ATTACHMENT 2

MARKED UP PAGES FOR
PROPOSED CHANGES TO APPENDIX A
TECHNICAL SPECIFICATIONS OF
FACILITY OPERATING LICENSES
NPF-37, NPF-66, NPF-72, AND NPF-77

BYRON STATION UNITS 1 & 2

BRAIDWOOD STATION UNITS 1 & 2

Figure 2.1-1
Reactor Core Safety Limit - Four Loops
in Operation

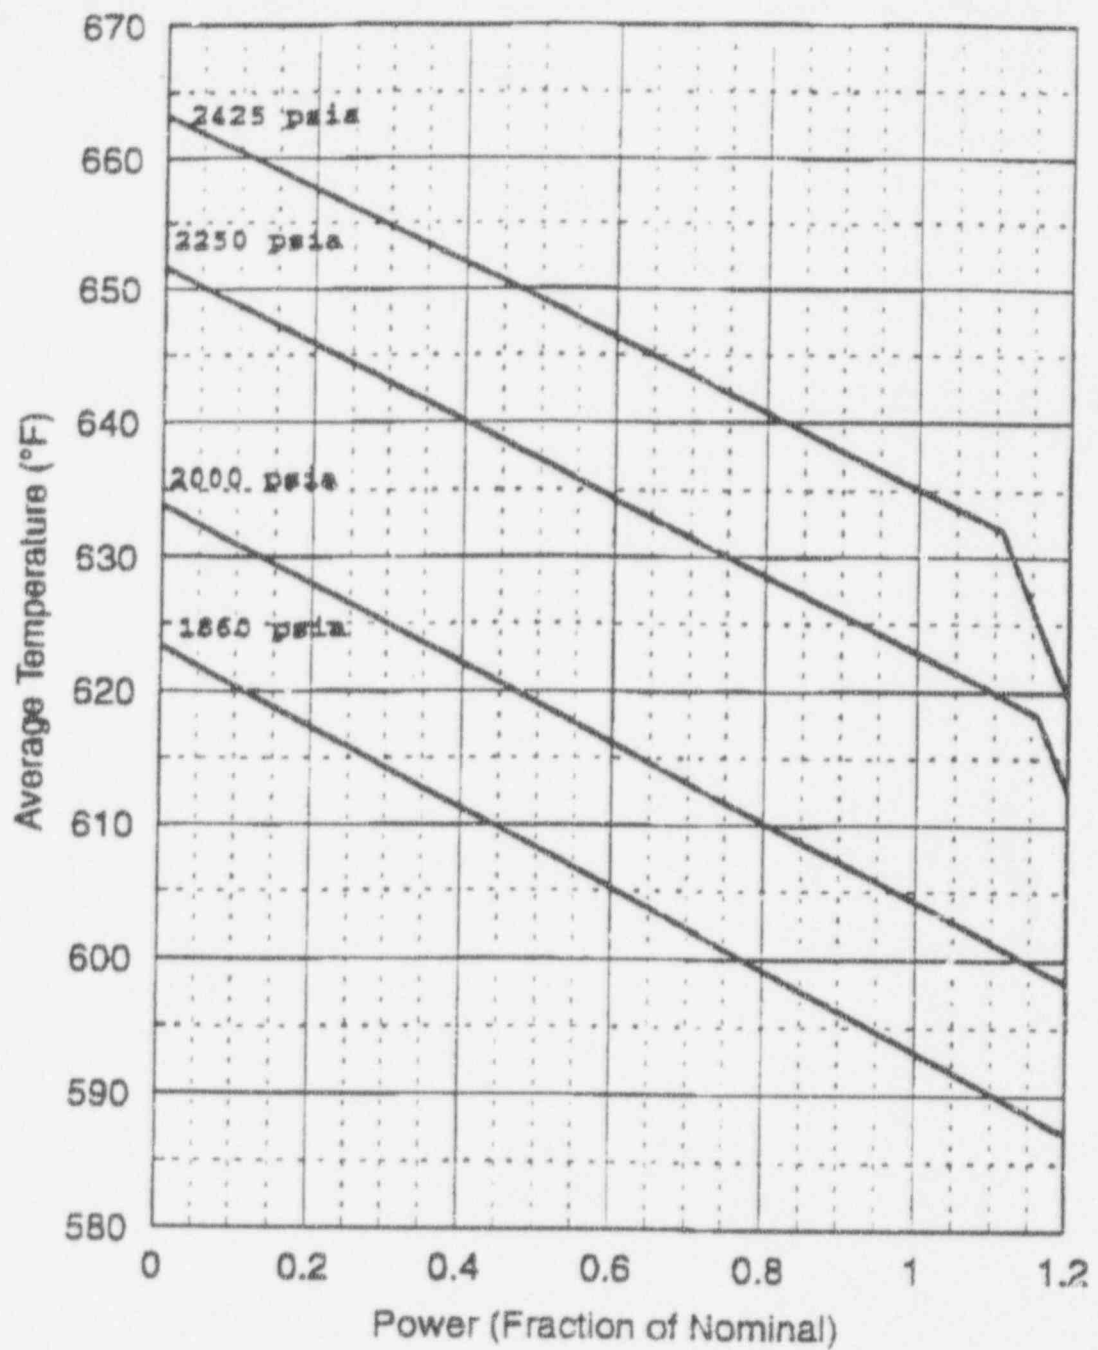
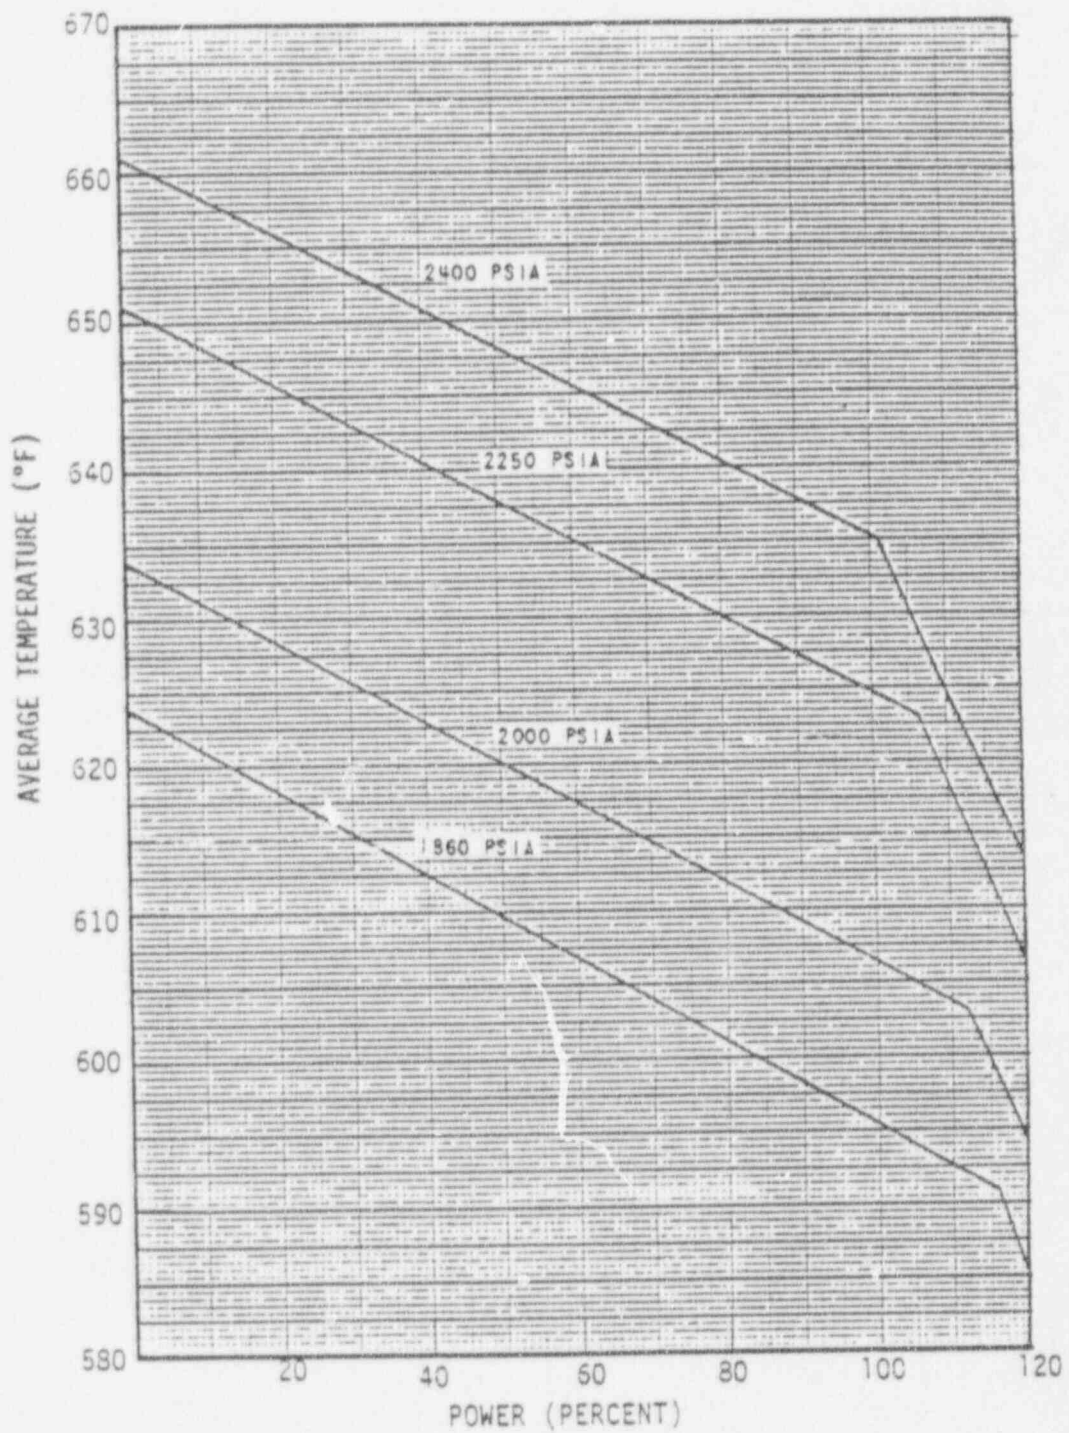
2.1.1 The combination of THERMAL POWER, pressurizer pressure, and the highest operating loop coolant temperature (T_{avg}) shall not exceed the limits shown in Figure 2.1-1* for four loop operation.

APPLICABILITY: MODES 1 and 2. (Figure 2.1-1a**)

* Applicable to Unit 1. Applicable to Unit 2 after cycle 5.

** Not Applicable to Unit 1. Applicable to Unit 2 until completion of cycle 5.

Applicable to Unit 1. Not Applicable to Unit 2 until
completion of cycle 5.
2-2

Not Applicable to Unit 1. Applicable to Unit 2 until completion
BYRON - UNITS 1 & 2 of cycle 5_{2-2a}

FIGURE 2.1-1

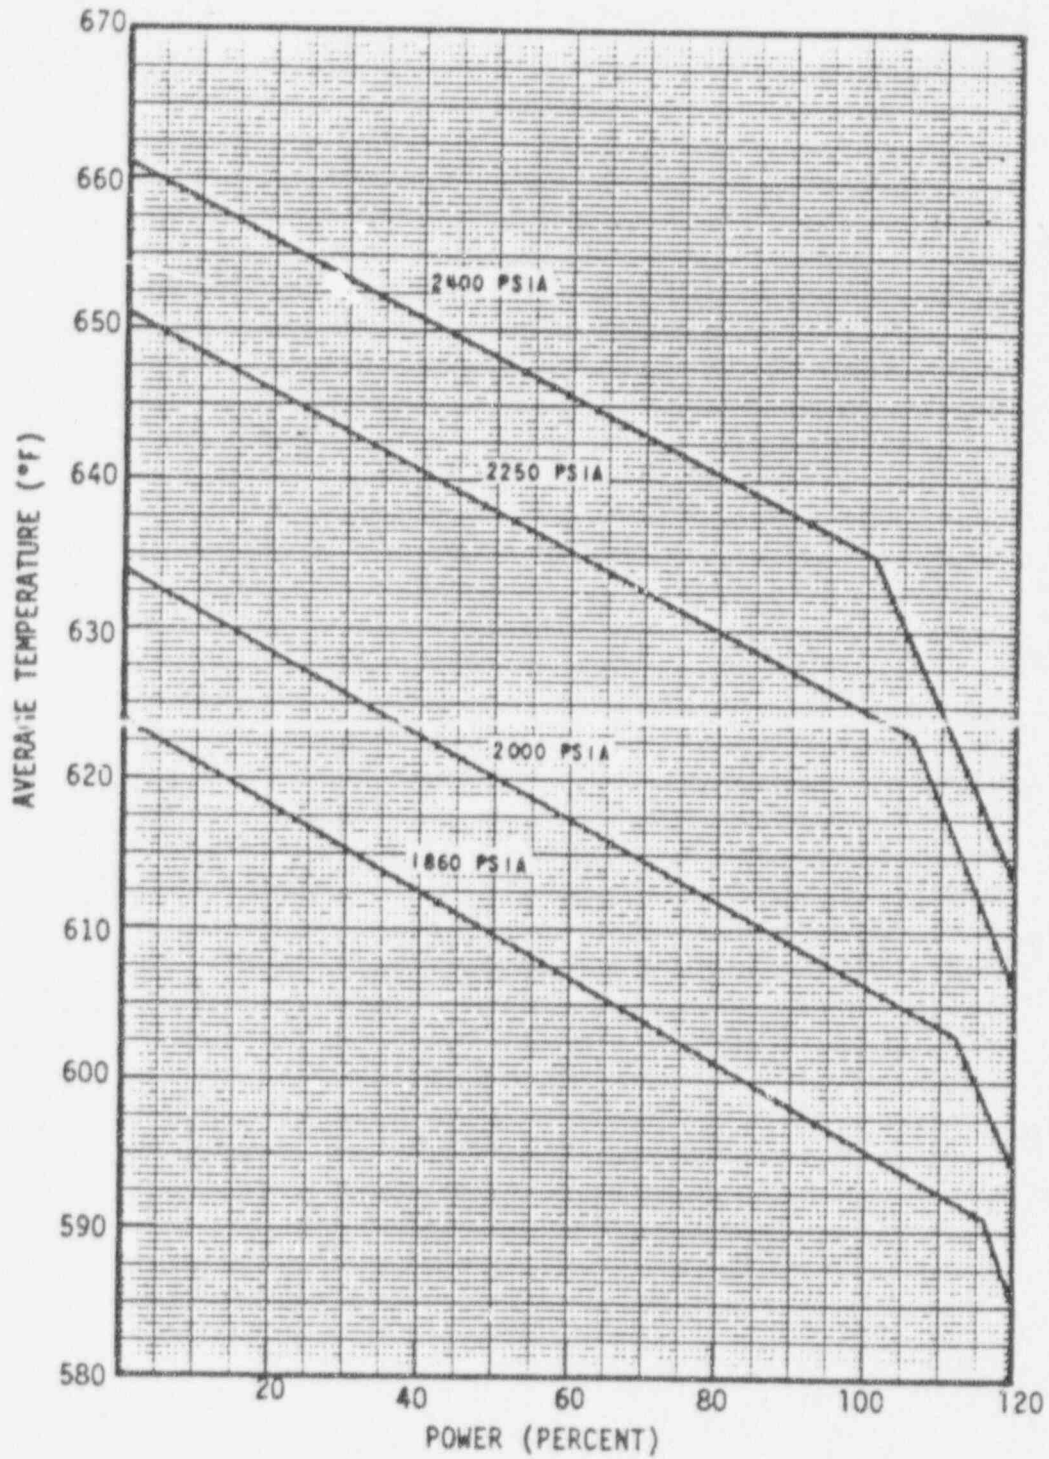
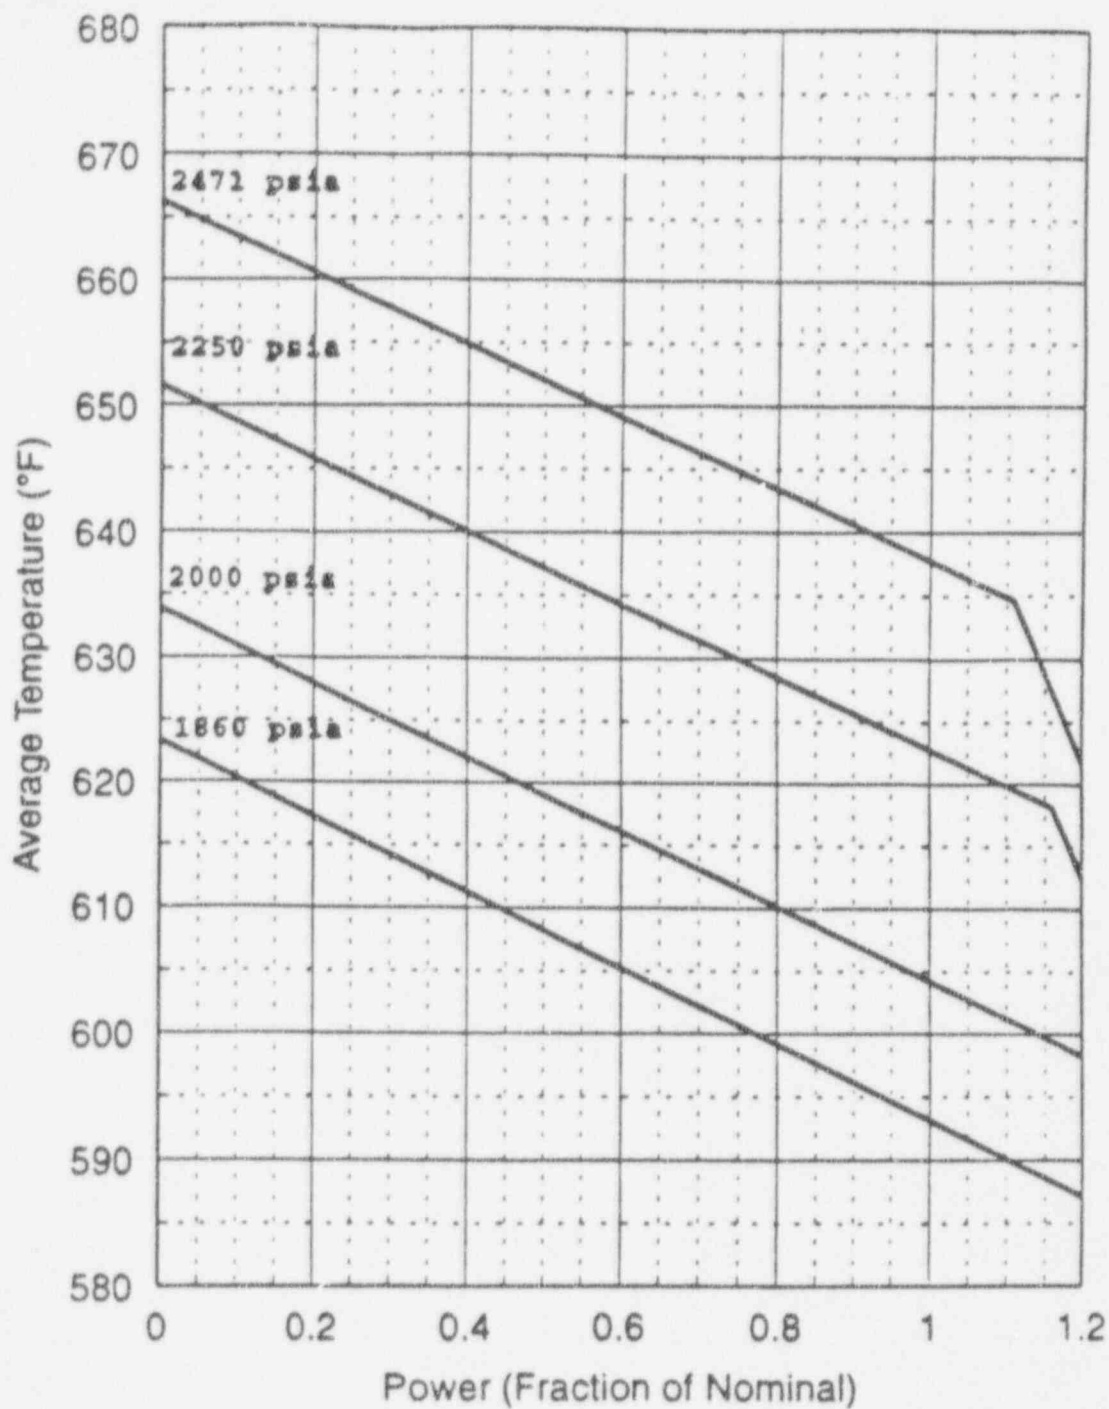
2.1.1 The combination of THERMAL POWER, pressurizer pressure, and the highest operating loop coolant temperature (T_{avg}) shall not exceed the limits shown in Figure 2.1-1* for four loop operation.

APPLICABILITY: MODES 1 and 2. (Figure 2.1-1a)**

* Applicable to Unit 1 and Unit 2 until completion of cycle 5.

** Applicable to Unit 1 and Unit 2 starting with cycle 6.

Applicable to Unit 1 and Unit 2 until completion of cycle 5.
BRAIDWOOD - UNITS 1 & 2

Applicable to Unit 1 and Unit 2 starting with cycle 6.
2-2a
